**NL-The Hague: EDF — components for multifunctional platforms (MFP) and productive use containers (PUC)
2010/S 2-000794**

Supply procurement notice

1. **Publication reference:**
EuropeAid/128651/D/SUP/TZ.
2. **Procedure:**
Open.
3. **Programme:**
EDF.
4. **Financing:**
Grant contract 9.ACP.RPR.49, commitment No: 12.
5. **Contracting authority:**
Humanist Institute for Co-operation with Developing Countries (HIVOS), Raamweg 16, 2596 HL The Hague, NETHERLANDS. The contracting authority's implementing partner is Tatedo, PO Box 32794, Plot 589, Off Shekilango Road, Kijitonyama, Dar es Salaam, TANZANIA.

Components for Multi Functional Platforms (MPF) and Productive Use Containers (PUC)

Question 38; Lot7 + Lot 8

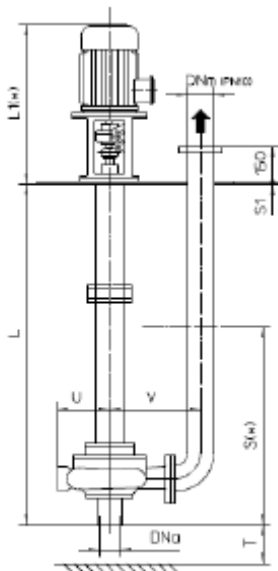
We are still a little confused with regards to how many containers are required. The specification and the delivery tables indicate that 50 containers are required for the Solar part of this tender, and 25 containers for the other part. In the tender document the model financial offer format it says 50 x 2 in lot 7 and 25 x 2 in lot 8. It also state that all lot 7 to be loaded into 2 containers ? is this correct, and the same for lot 8. Manufactures of the solar products have indicated it will take at least double that quantity of containers, so where do the extra containers come from.

Regarding the number of containers, please see our response on question 28 & 29. Regarding the logistics, you are free to implement this as you feel is most convenient as long as it is in line with the requirements of the tender dossier.
